REQUEST FOR PROPOSALS "RFP" NO. PS20171423  
DESIGN-BUILD REPLACEMENT GAS FLARE STACKS AT THE VANCOUVER LANDFILL

QUESTIONS AND ANSWERS NO. 2

ISSUED ON MARCH 20, 2018

FLARE STATION  
STRUCTURAL LAYOUT PLAN

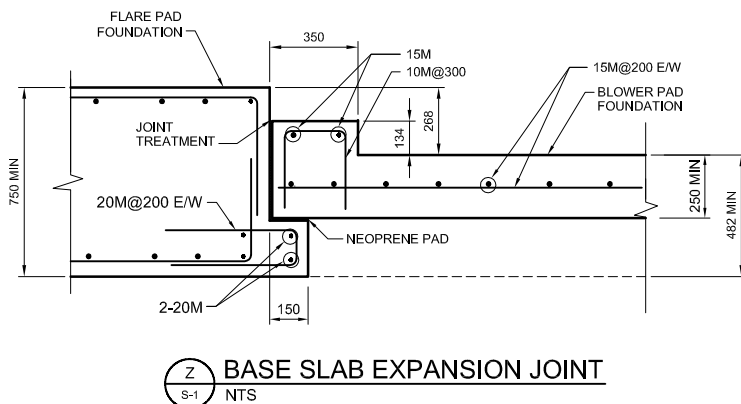
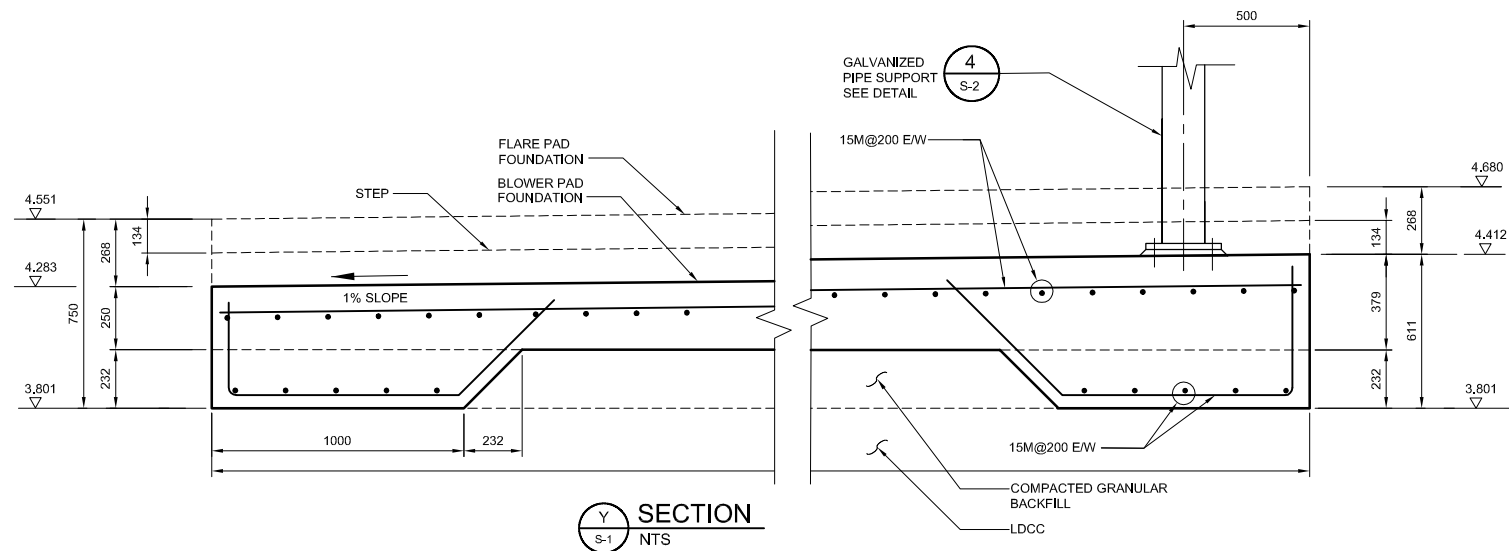
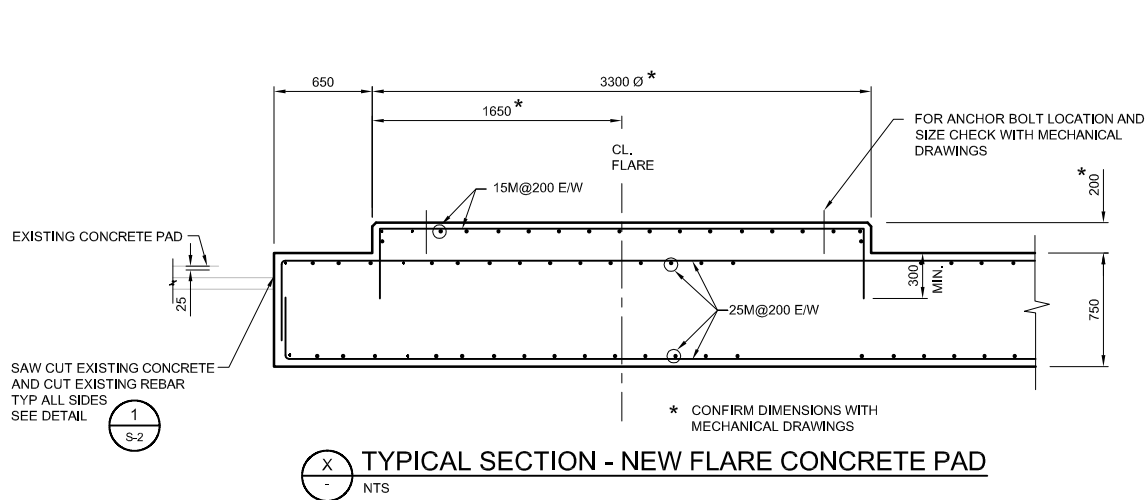
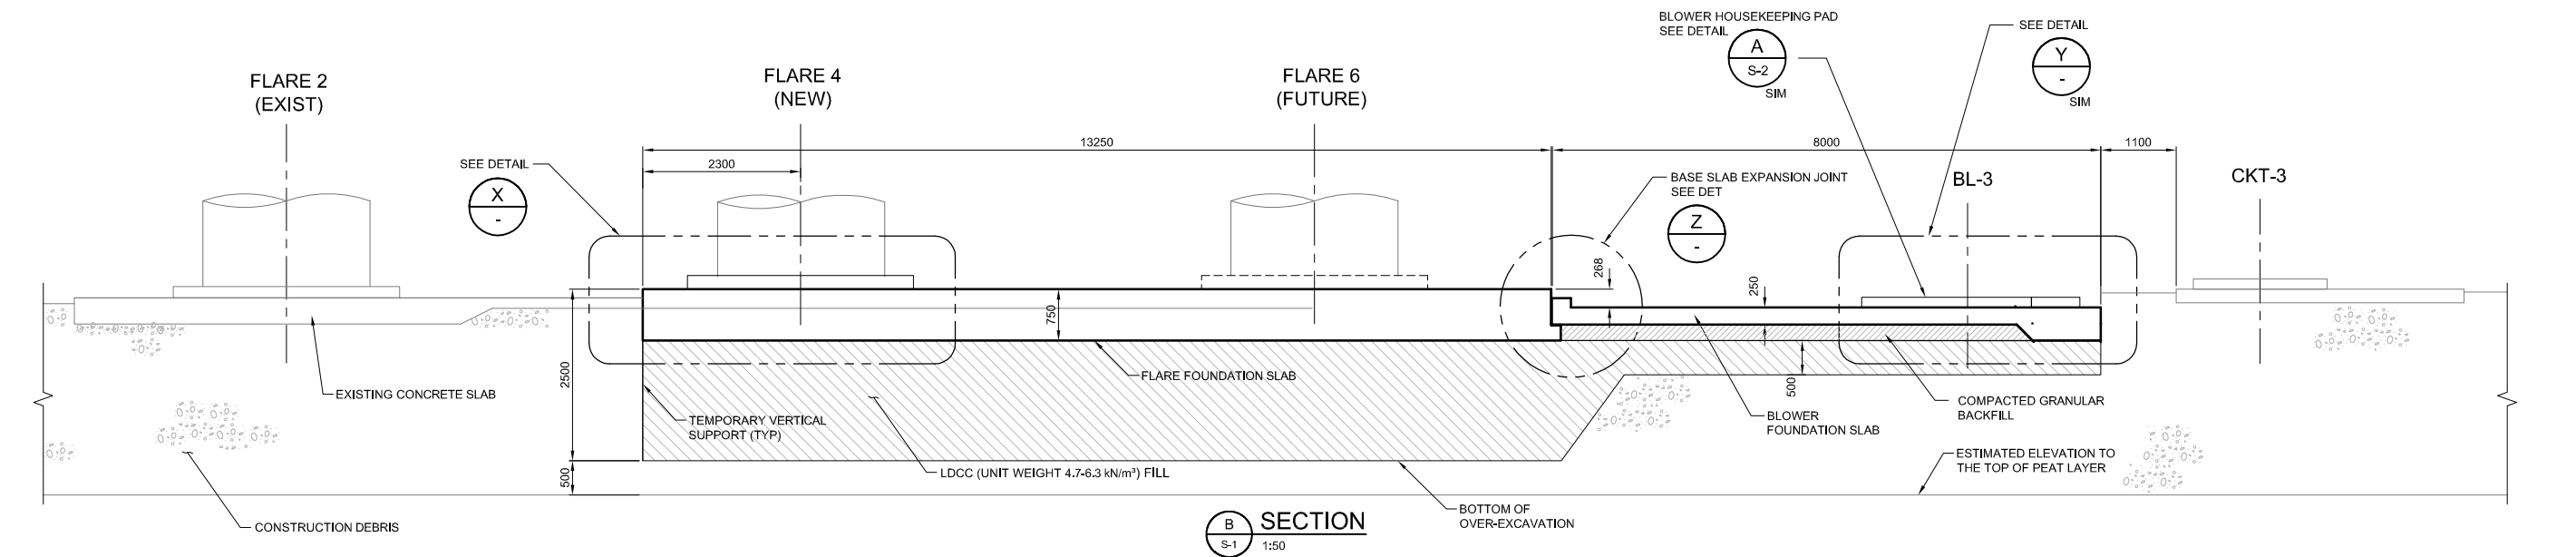
<p>b) No the remote panel should have sufficient inputs and outputs that pertain to flares 5 and 6 only. With 30% contingency for future inputs and outputs for additional instrumentation for flares 5 and 6</p> <p>c) Guidelines for spares should be to have one of each input and outcard type for flares 5/6</p> <p>d) Criteria for the Controllogix CPU will be memory size, minimum of 2 MB. Recommendation is the L71 CPU</p> <p>e) The Design Builder will be responsible for the integration of the new flares with the old flares. The City's SCADA team can support the Design Builder with the integration.</p>
Q4	Section 3.5 of the RFP (page B-15) indicates that the design-builder shall assume the responsibility to assess the structural suitability and integrity of the existing concrete pad for the pedestals and for the structural design/installation of the pedestals for the Flares 5 and 6 based on the information provided within the RFP and attached reports. Can the City provide the stamped as-built drawing and technical specifications for the existing concrete pad?

A4	Please refer to stamped and sealed City of Vancouver Phase 1 Closure Project Record Drawings S-2A, S-3, S-1, S-2 and Section 03306 Concrete Work (attached).
Q5	It is necessary to strictly follow the specifications of the RFP in order to have a compliant proposal? For example, some of the technical requirements no longer meet industry standards and/or have been replaced with other methods. Our intention is to provide only one proposal with the most up to date CSA code compliant equipment and systems, which may not necessarily strictly follow the specifications. Please confirm that this is acceptable and compliant.
A5	<p>The 30% schematic designs and draft technical specifications prepared by CH2M constitute the Reference Concept. As stated in the RFP, the Reference Concept is provided for information purpose and to communicate a general approach for the LFG flare replacement only, and may not meet all of the City's performance, technical, contractual or regulatory requirements. It is anticipated that the Design-Builder will review the Reference Concept, and using independent professional judgement, refer to the Reference Concept as they see fit, in the preparation of their proposals and in the development of detailed designs and construction packages.</p> <p>It is the responsibility of the Design Builder to ensure that they develop detailed design packages and technical specifications which meet all the most up to date municipal bylaws, design codes, regulations and standards.</p>
